UNITED STATES
DEPARTMENT OF THE INTERIOR
BUREAU OF LAND MANAGEMENT
OCD ArtesiaFORM APPROVED
OMB NO. 1004-0137
Expires: January 31, 2018**SUNDRY NOTICES AND REPORTS ON WELLS**
Do not use this form for proposals to drill or to re-enter an abandoned well. Use form 3160-3 (APD) for such proposals.5. Lease Serial No.
NMNM45235

SUBMIT IN TRIPLICATE - Other instructions on page 28. Well Name and No.
PURE GOLD C-17 FEDERAL 49. API Well No.
30-015-2715310. Field and Pool or Exploratory Area
W SAND DUNES11. County or Parish, State
EDDY COUNTY, NM

DEVON ENERGY PRODUCTION COMPANY LP

**Permanent Abandonment of Federal Wells
Conditions of Approval (LPC Habitat)**

CURRENT WELLBORE

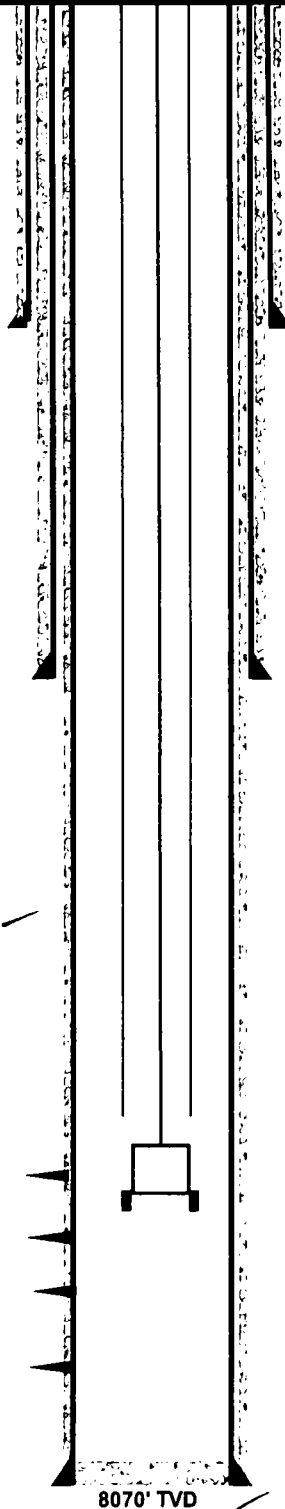
3. Set CIBP @ 6000' Spot 20 sx CI C 5900-6000. WOC & tag (Open perfs at 6267') CIBP 6200, spot 25 sx min

4. Spot 20 sx CI C 6000-6100. WOC & Tag (DV tool 6051') 6100 25 sx min. 160' plug

5. Spot 225 sx CI C @ 4560-2831. WOC & tag (R-111P, T. Delaware 4510', B. Salt 4200', Shoe 4090')

6. Spot 225 sx CI C @ 2831-550. WOC & tag (R-111P, T. salt 1102, shoe 604')

7. Perf @ 140'. Pump 35 sx CI C in/out to surface.

(well inside R-111P boundary. Salt section noted @ 1,102' - 4,200')

Below ground level dry hole marker required
